# MIDWAY BUSINESS PARK

GRADING AND DRAINAGE PLAN
INTERWEST APPLIANCE

JOB NO. 880671
DATE 6-88
SHEET 1 OF 1

GRADING AND DRAINAGE PLAN
INTERWEST APPLIANCE

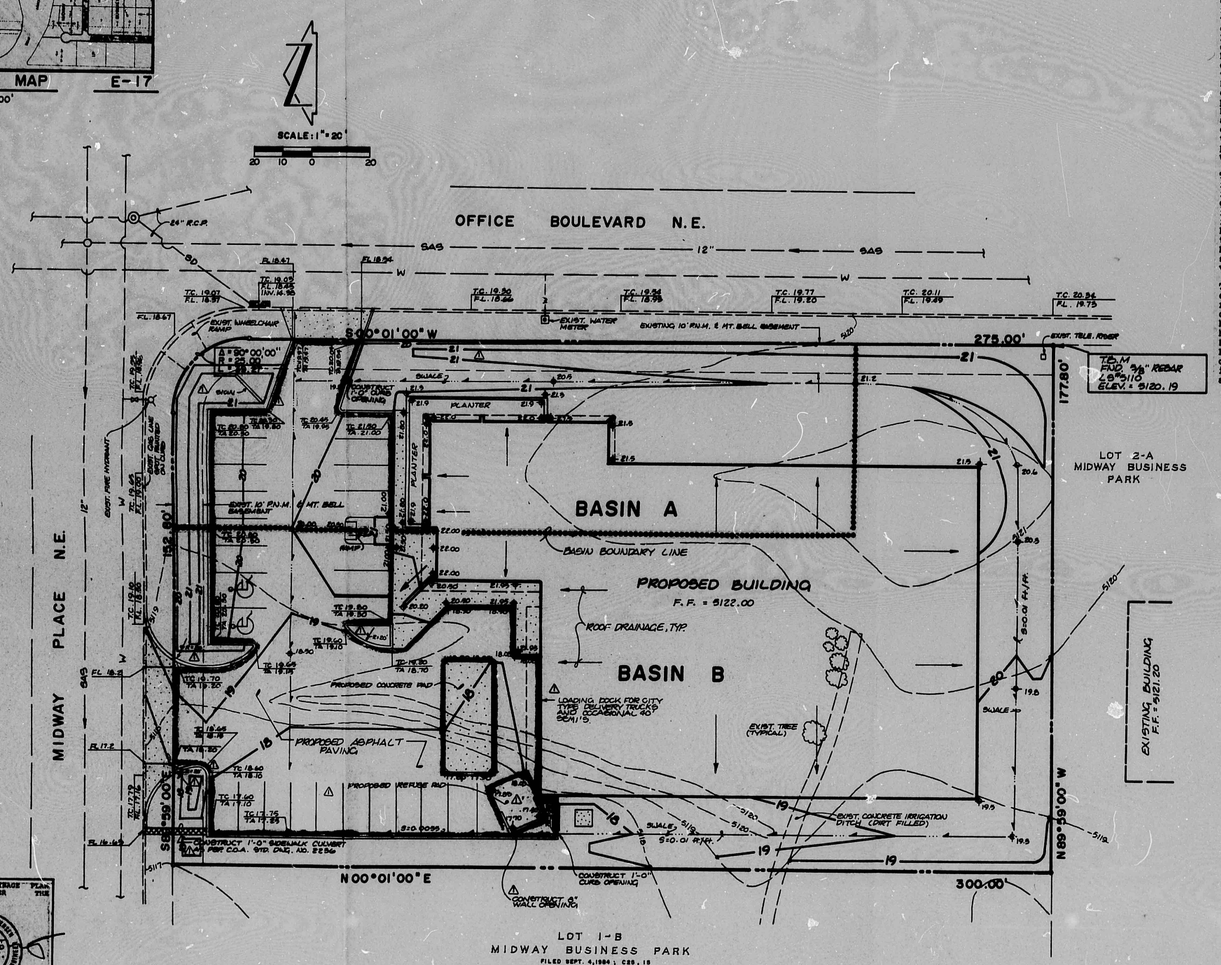
| No. | Date | By | Revision |
|---|---|---|---|
| 1 | 9/88 | G.C.J. | INCREASE DRIVEWAY TO 30' WIDTH-TO CURB RETURNS; INCREASE TO 20' RADIUS. - RELOCATE REFUSE PAD & ADJUST PARKING. INCREASE PLANTER TO 30' WIDTH. SHOW SIGNING ADJACENT TO SIDEWALK. MOTION OF DELIVERY TRUCKS. |

GRADING AND DRAINAGE PLAN
INTERWEST APPLIANCE

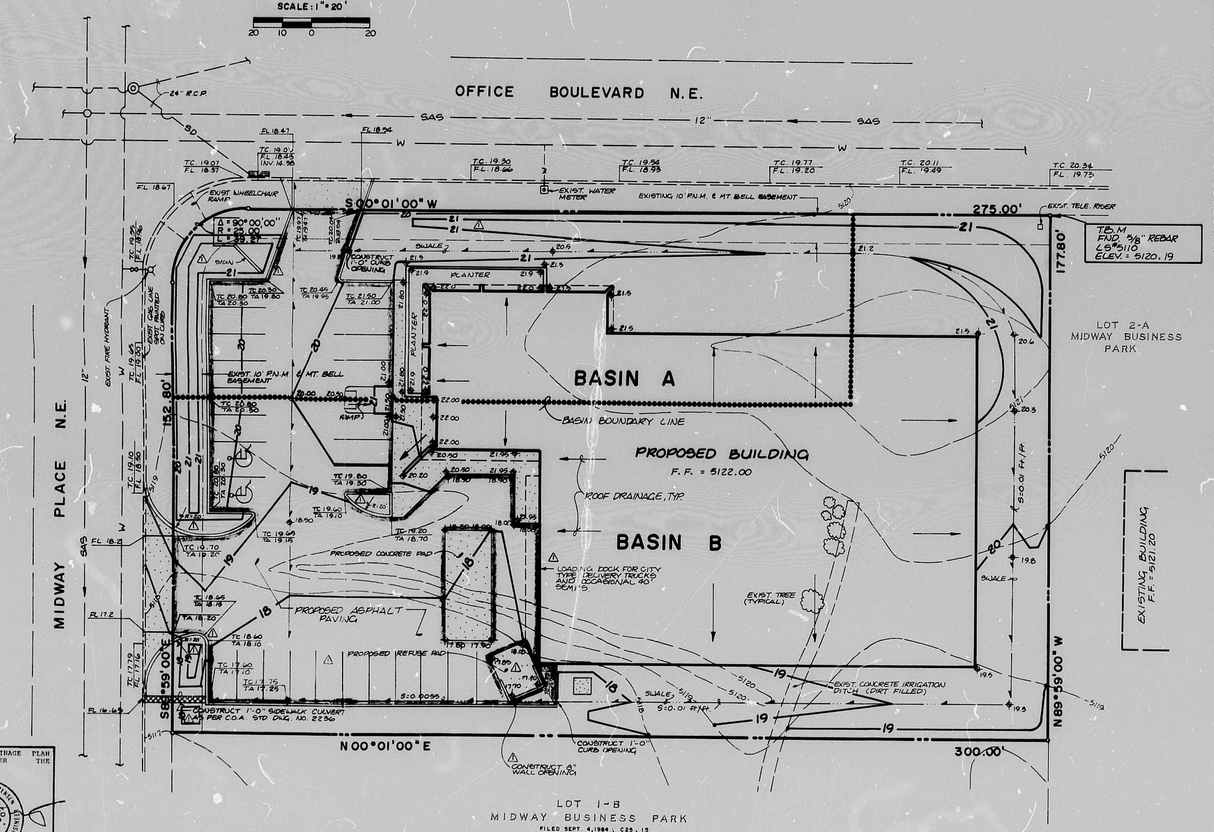
| No. | Date | By | Revision |
|---|---|---|---|
| 1 | 9/88 | G.C.J. | INCREASE DRIVEPAD TO 30' WITH FLARES RETURNS. INCREASE TO 20' RADII. RELOCATE REFUSE PAD & ACCESS. PARKING. INCREASE SWALES TO 20' RADIUS. SHOW BERMS ADJACENT TO SIDEWALK. ROUTION OF DELIVERY TRUCKS. |
